1. ptc. Greengate, 3-9 Reserve Street, 222, 226, 228-230 Derby Street, and 106 Woodriff Street, Penrith NSW 2750 - Response to Traffic Comments (DA18/1244)

PROJECT:
The Village Green, Penrith

DRAWING TITLE:
Car Park Assessment -
B85 Swept Paths

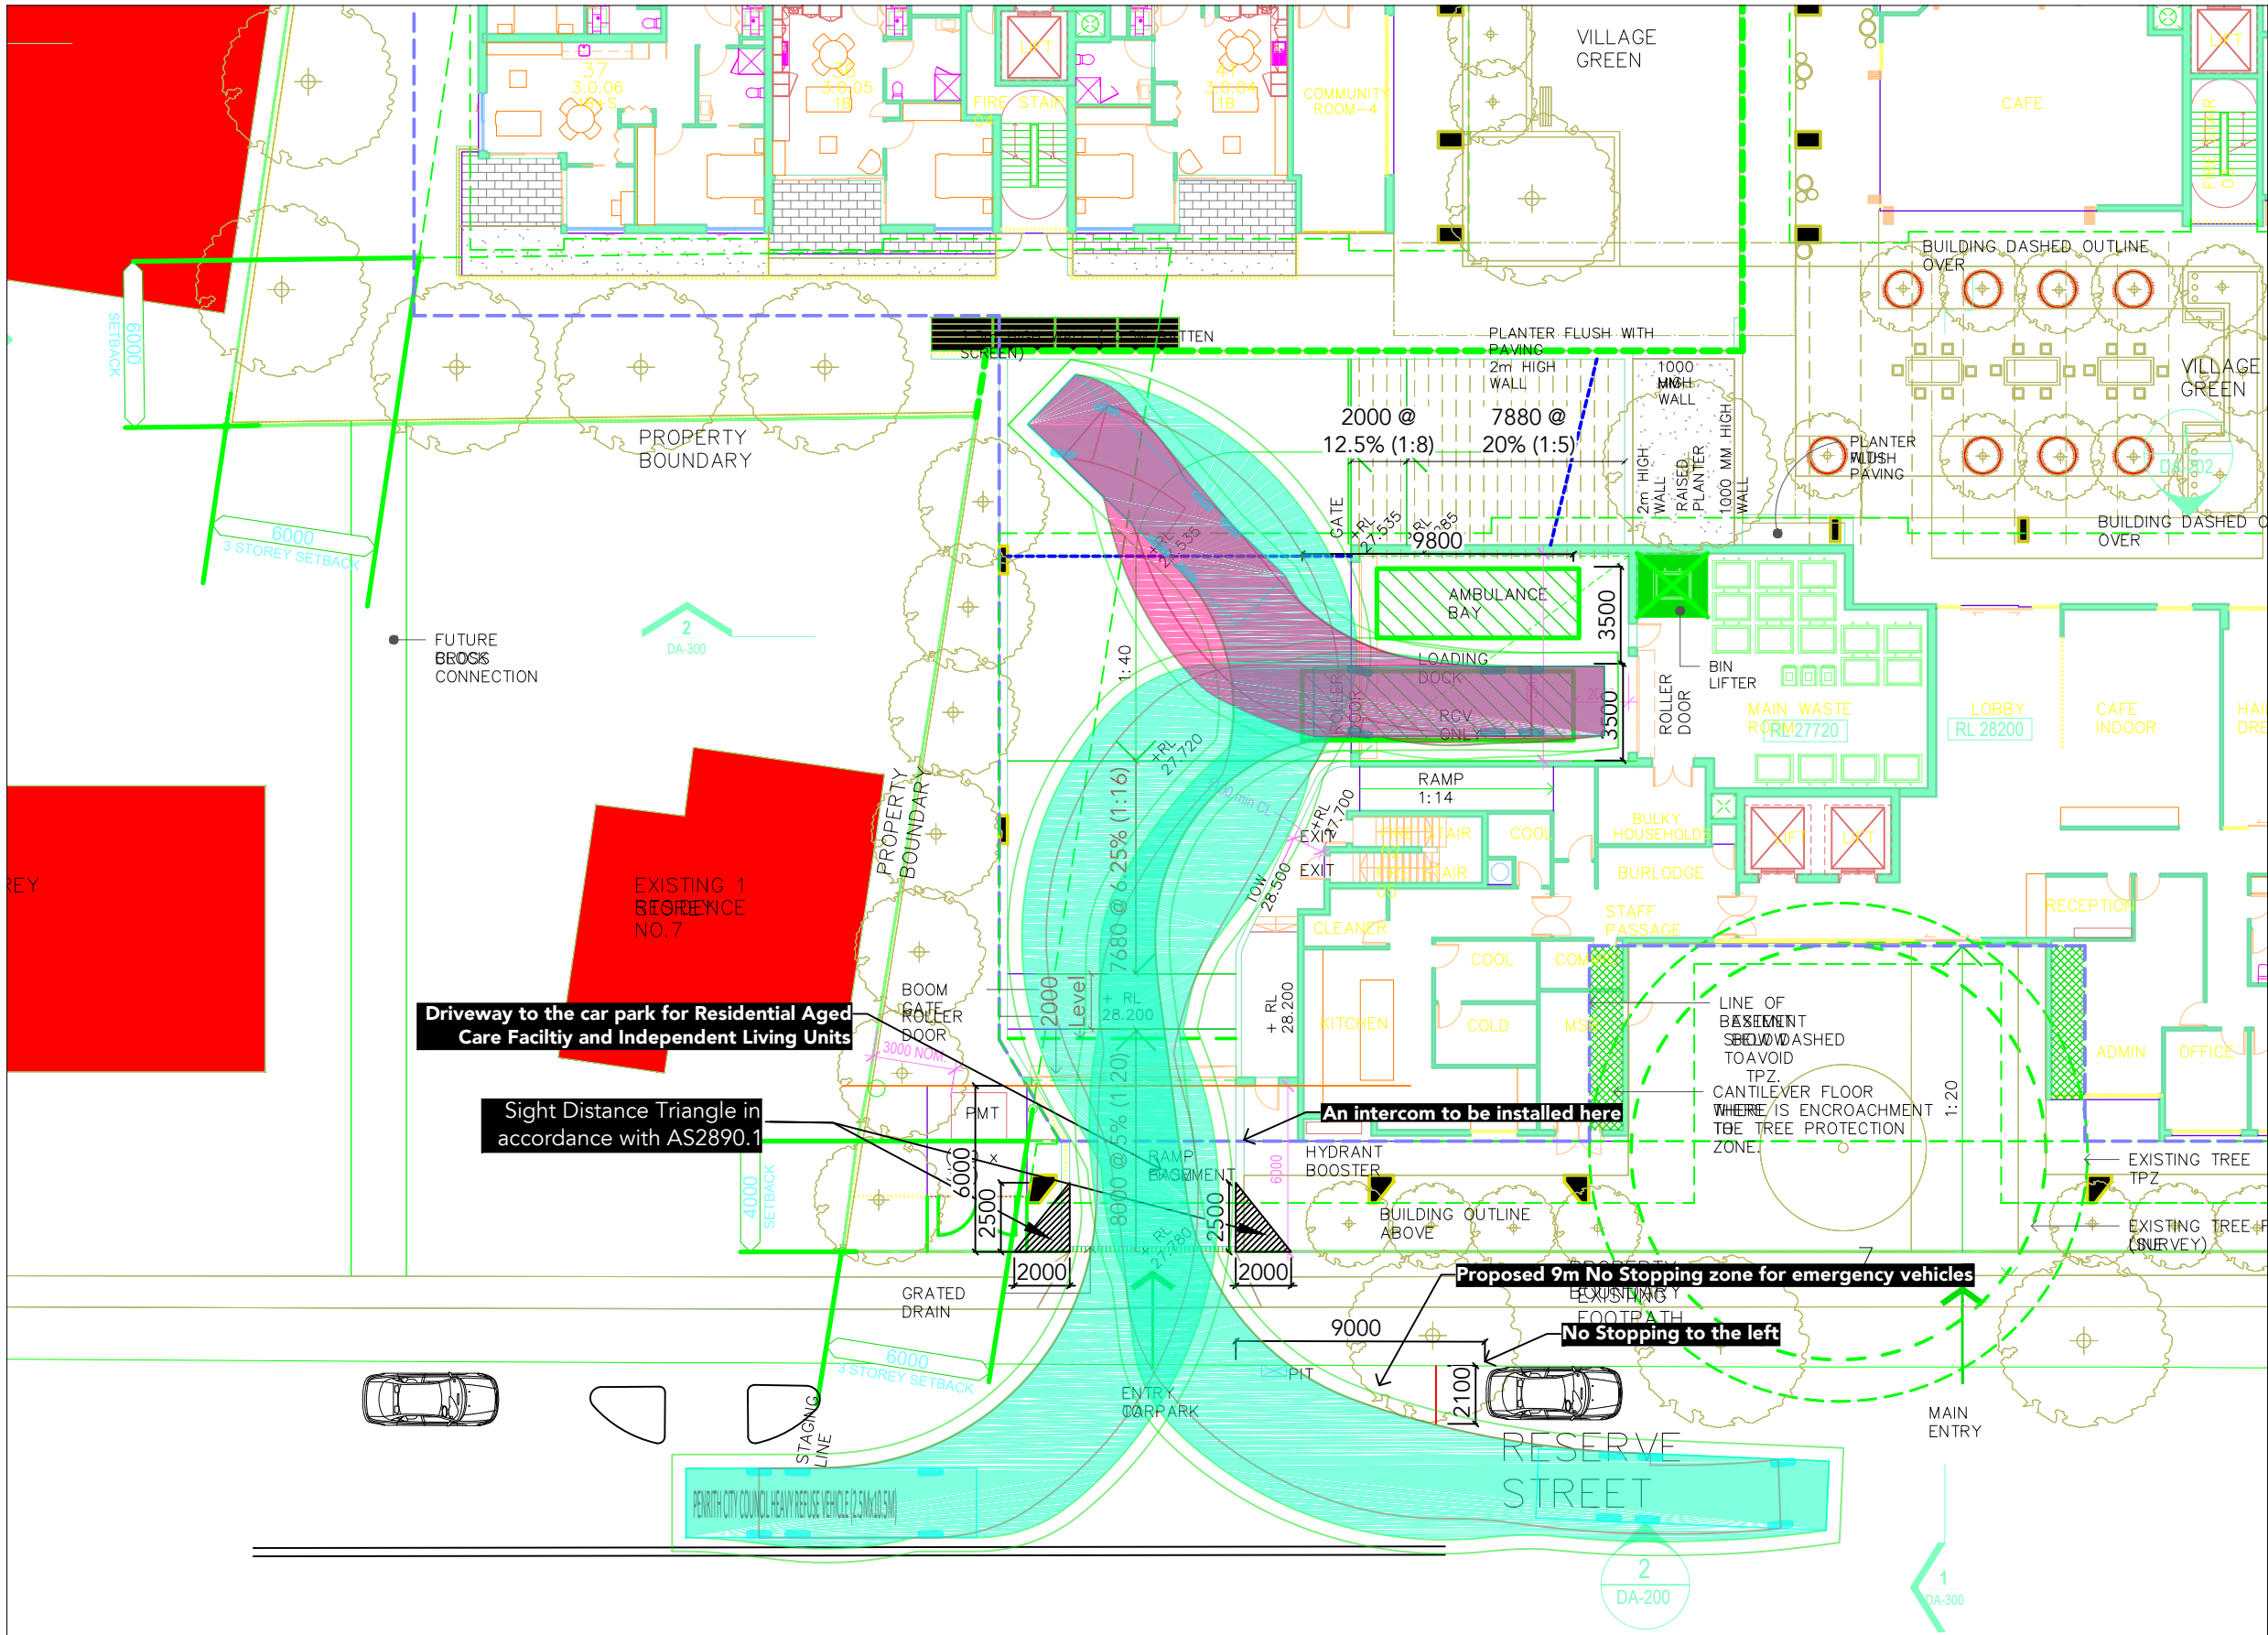
The layout appears to be confusing for drivers with limited areas to turn around if all parking spaces are occupied. The swept paths provided indicate that access is extremely tight, with some vehicles needing to reverse the full length of the aisle to exit a car parking space. This is not supported.

The plans have been revised to identify the parking spaces that will be assigned to specific residents. The area of the parking that contains dead-end aisles is solely allocated to residents meaning that each parking space will be available to the associated resident on arrival, which negates the need for turning areas at the end of each dead-end aisles.

PENRITH CITY COUNCIL HEAVY REFUSE VEHICLE (2.5Mx10.5M)

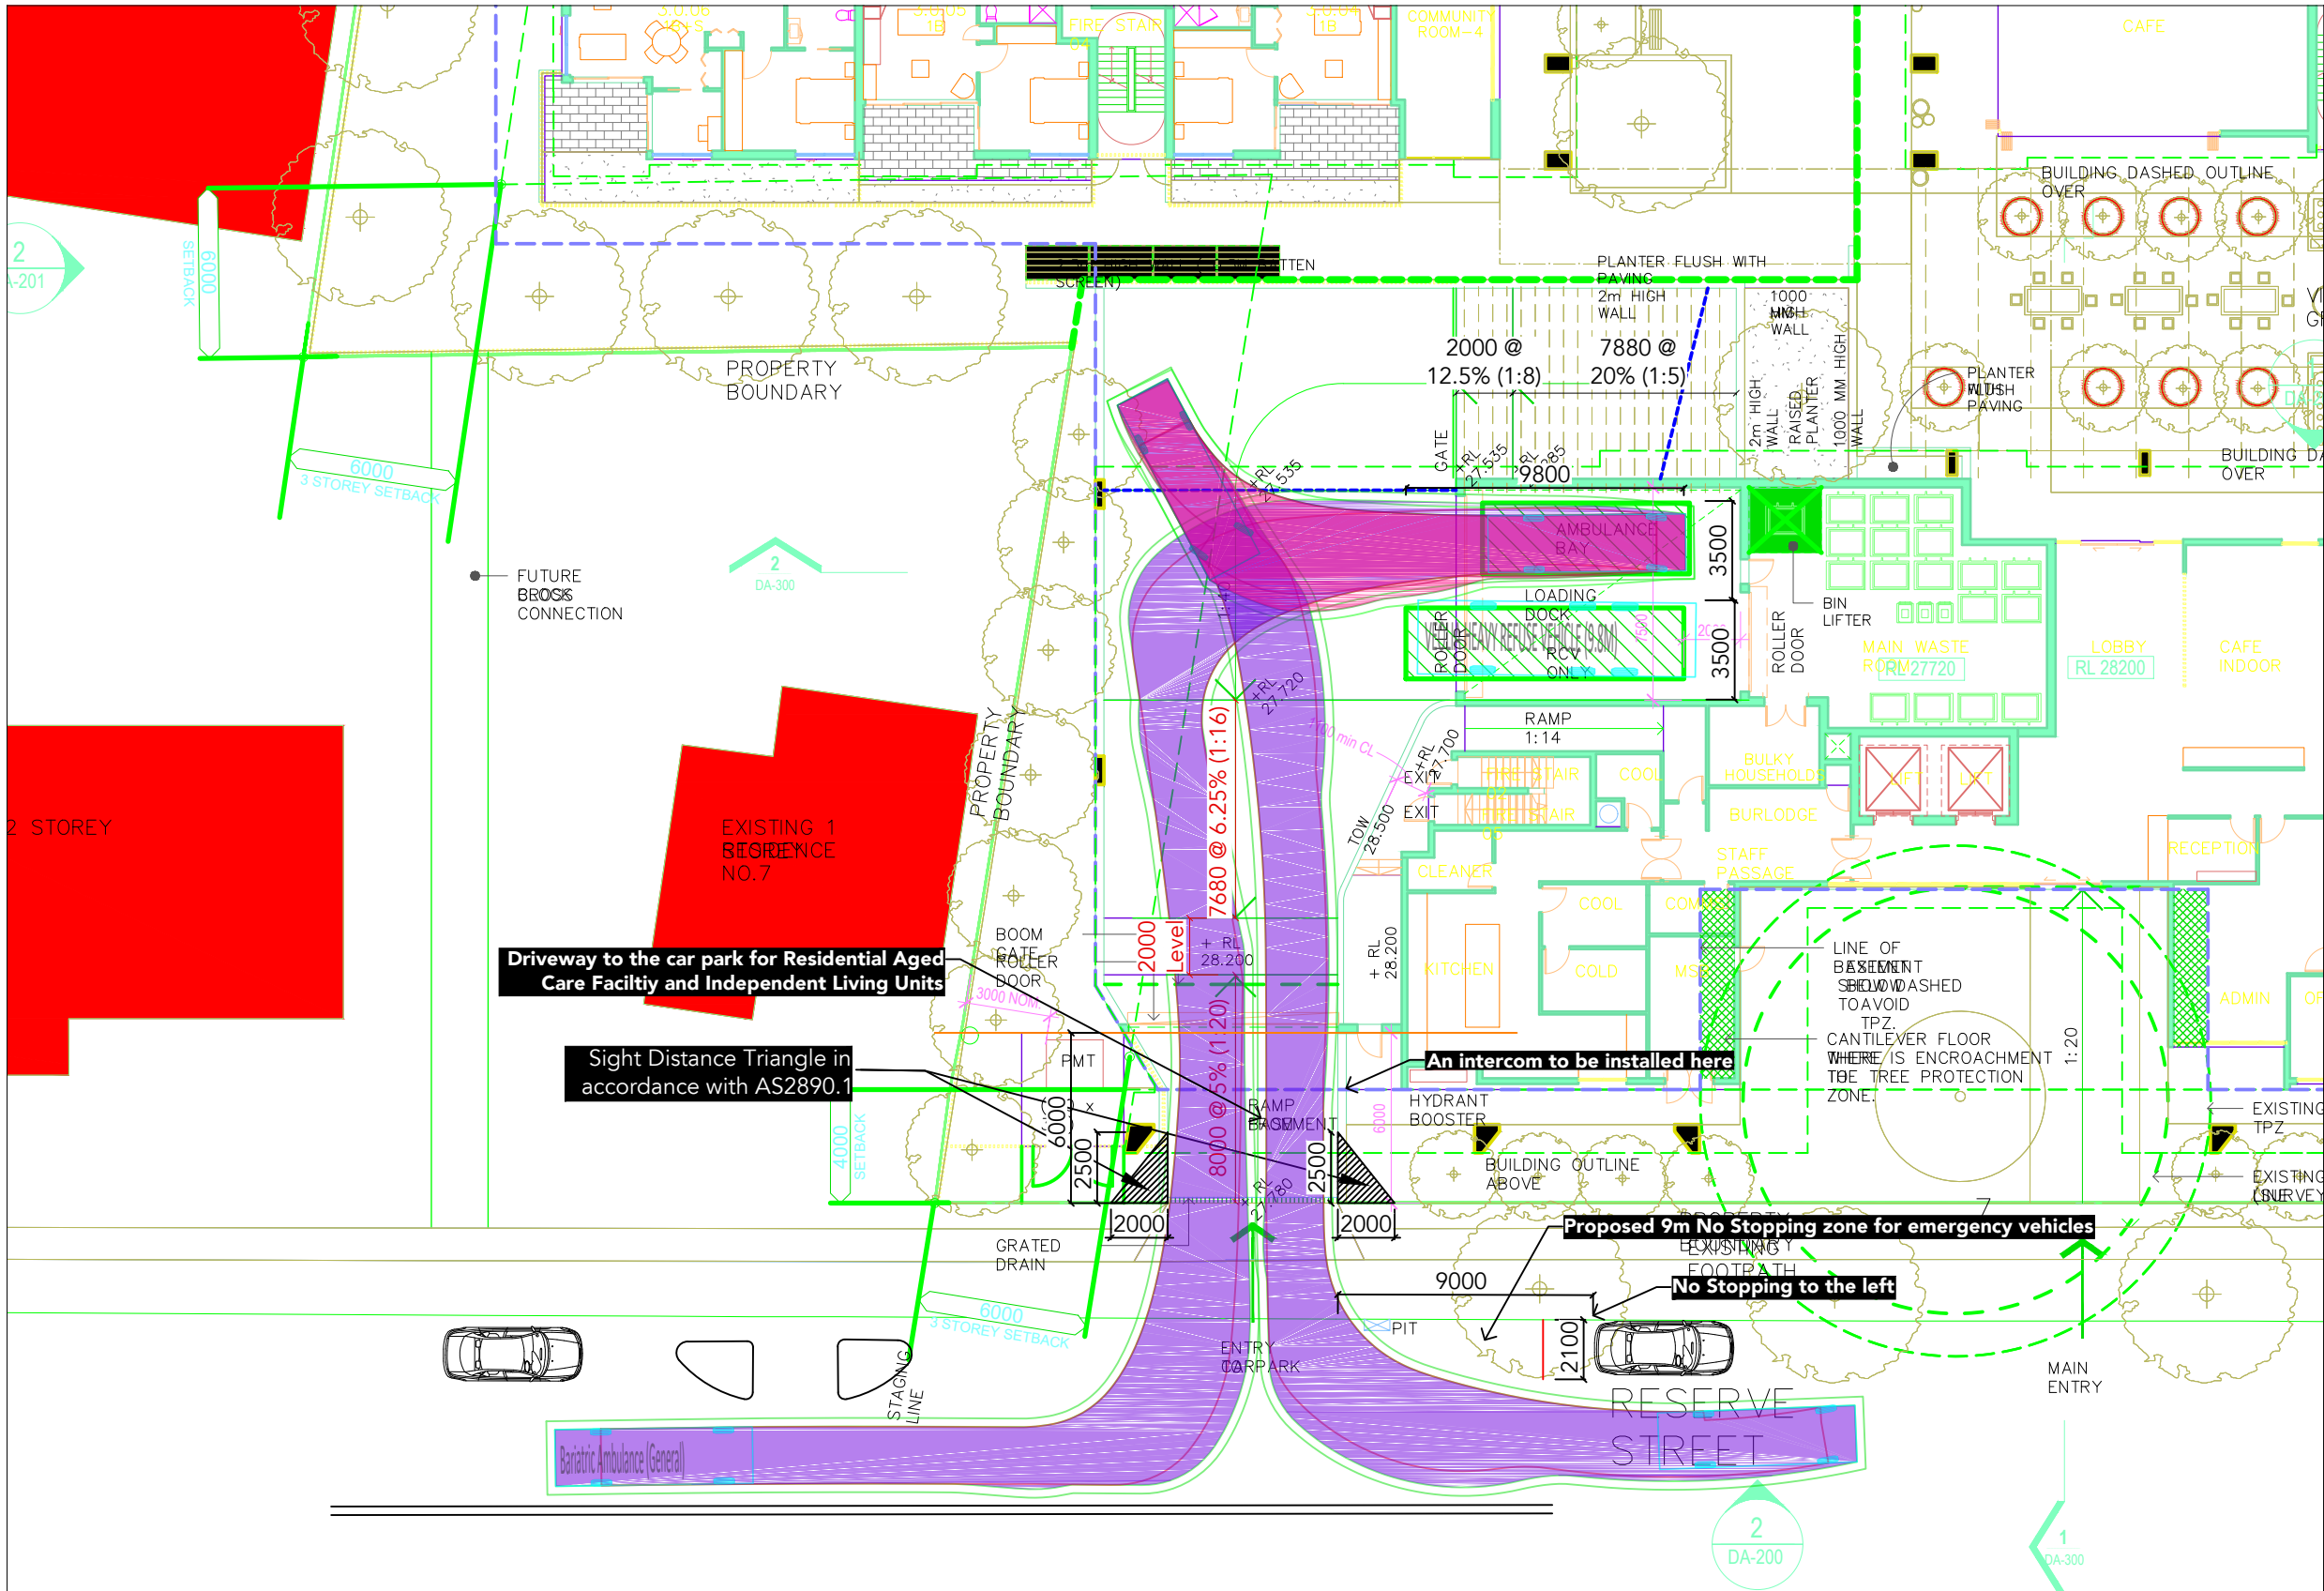
There is still inadequate separation of the loading areas from the car park access ramp.

Two service vehicle bays are provided at ground level in loading dock, one is proposed for ambulance parking, one for waste/deliveries. However, a reverse manoeuvre is required from the ramp at the bend which is not supported.

The turning area associated with the loading area has been amended to increase its size by relocating the outer northern and western walls to the north and west respectively. In relation to the comments made in the Waste section of Council's letter, we have also run the swept paths using the standard MRV (to represent a commercial waste contractor vehicle) and Council's waste vehicle according to the dimensional details made available. It should be noted that the vehicle width has been maintained at 2.5m, as this is the legal maximum width of a vehicle. It is presumed that the width of 2.8m provided in the vehicle specification refers to the width including wingmirrors.

The swept paths are attached and demonstrate that both vehicle sizes are able to access and depart the loading area with more than a 500mm clearance from obstructions at any point on the paths.

The manoeuvring area has a maximum grade of 1 in 40, which is provided to reduce the levels sufficiently to minimise the length of the car park ramp and to ensure that stormwater drains to a point within the site. The car park ramp is located to the east of the turning area and is not used in any part of the truck manoeuvre, which is clear of the ramp (including the transition).
